Mark B. Bezilla
Vice President440-280-5382
Fax: 440-280-8029December 15, 2010
L-10-200

Perry Nuclear Power Plant
Docket No. 50-440, License No. NPF-58
License Amendment Request to Modify Technical Specification 3.1.4, "Control Rod Scram Times," to Incorporate TSTF-222-A, Revision 1

Subject: Modification of Required Testing Frequencies Within Perry Nuclear Power Plant (PNPP) Technical Specification 3.1.4, "Control Rod Scram Times"

SURVEILLANCE REQUIREMENTS

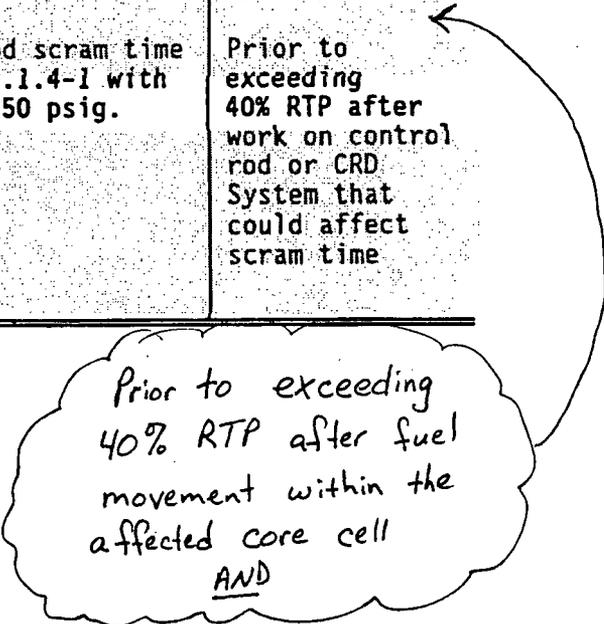
SURVEILLANCE	FREQUENCY
SR 3.1.4.1 Verify each control rod scram time is within the limits of Table 3.1.4-1 with reactor steam dome pressure \geq 950 psig.	<div style="border: 1px solid black; border-radius: 50%; padding: 10px; display: inline-block;"> Prior to exceeding 40% RTP after fuel movement within the reactor pressure vessel AND (continued) </div>

SURVEILLANCE	FREQUENCY
SR 3.1.4.1 (continued)	Prior to exceeding 40% RTP after each reactor shutdown \geq 120 days
SR 3.1.4.2 Verify, for a representative sample, each tested control rod scram time is within the limits of Table 3.1.4-1 with reactor steam dome pressure \geq 950 psig.	120 days cumulative operation in MODE 1
SR 3.1.4.3 Verify each affected control rod scram time is within the limits of Table 3.1.4-1 with any reactor steam dome pressure.	Prior to declaring control rod OPERABLE after work on control rod or CRD System that could affect scram time
SR 3.1.4.4 Verify each affected control rod scram time is within the limits of Table 3.1.4-1 with reactor steam dome pressure \geq 950 psig.	Prior to exceeding 40% RTP after work on control rod or CRD System that could affect scram time

Prior to exceeding 40% RTP after fuel movement within the affected core cell
AND
